5. Graham-Miller Subdivision #3; KPB File 2023-067 Johnson Surveying / Linda L. Graham Trust Location: Fifth Street Hope Area / Hope-Sunrise APC

KPB File No.	2023-067
Plat Committee Meeting:	July 17, 2023
Applicant / Owner:	Linda L. Graham Trust of Hope AK
Surveyor:	Jerry Johnson / Johnson Surveying
General Location:	Bear Creek Road, Hope, Alaska, Hope/Sunrise APC
Parent Parcel No.:	035-030-81
Legal Description:	Tract A1 of Graham – Miller Subdivision #2 SWD 2013-12
Assessing Use:	Residential
Zoning:	Rural Unrestricted
Water / Wastewater	On Site

ITEM 5 - GRAHAM – MILLER SUBDIVISION #3

STAFF REPORT

KPB File 2023-067

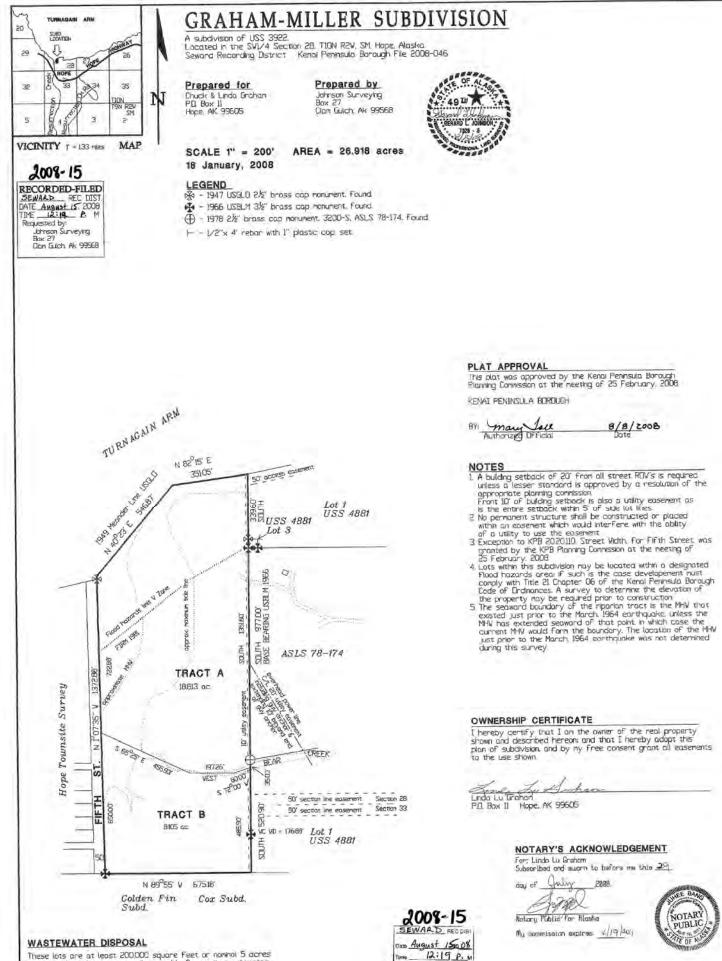
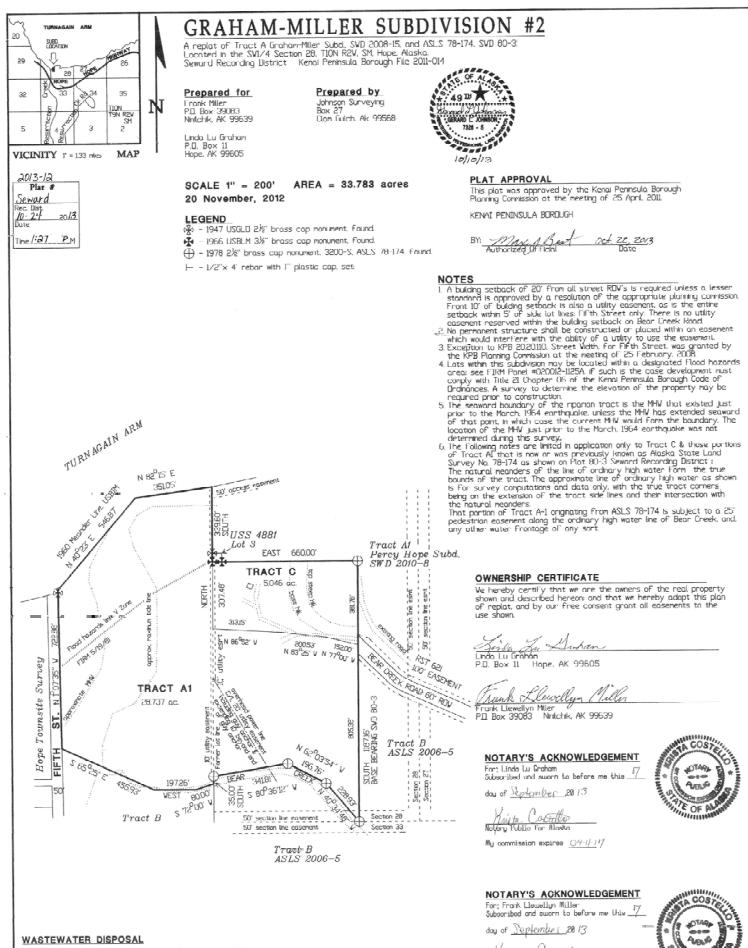
There are several structures located within both proposed lots and possibly in the utility easement. **Staff** recommends: the buildings be removed from the final plat.

Resolution 2015-03 appears to have vacated part of the 20-foot utility easement starting from the south end as shown. **Staff recommends:** showing that portion of the easement being vacated and referencing the resolution as the source.

- Add a legend
- Add the KPB number of 2023-067
- Correct any overstrikes on the face of the plat.

Staff recommendation: Modify legal as follows – A subdivision <u>of</u> Tract A1 Add the KPB No. 2023-067

Staff recommendation: C Street located to the west should be depicted and the width shown.

Staff recommendation: Correct the shape of the subdivision on the vicinity map. Correct the location on the map to the SE1/4. Add Bear Creek Road to the vicinity map. Correct any overstrikes.

- F. The location, width and name of existing and platted streets and public ways, railroad rights-of-way, easements, and travel ways existing and proposed, within the subdivision; **Staff recommendation:** Label the dedication on the drawing. Add a detail of the dedication for better clarification
- G. The status of adjacent lands within 100 feet of the proposed subdivision boundary or the land status across from any dedicated rights-of-way that adjoin the propose subdivision boundary, including names of subdivisions, lot lines, block numbers, lot numbers, rights-of-way; or an indication that the adjacent land is not subdivided;

Staff recommendation: Correct the labels to the southwest, move the labeling on the northeast. The Hope Townsite Survey to the west should have lots labeled that are within 100 feet of the subdivision.

- Approximate locations of areas subject to tidal inundation and the mean high water line; **Staff recommendation:** Change the line type for the MHW and minimum tide line to not be the same as a lot line.
- M. Approximate locations of slopes over 20 percent in grade and if contours are shown, the areas of the contours that exceed 20 percent grade shall be clearly labeled as such;
 Staff recommendation: Change the line type for areas of steep grade to not be the same as a lot line.

Staff recommendation: place the standard note on the plat for the flag lot(s): No structures are permitted within the panhandle portion of the flag lot(s). Exception requested was for panhandle longer than 150 feet.
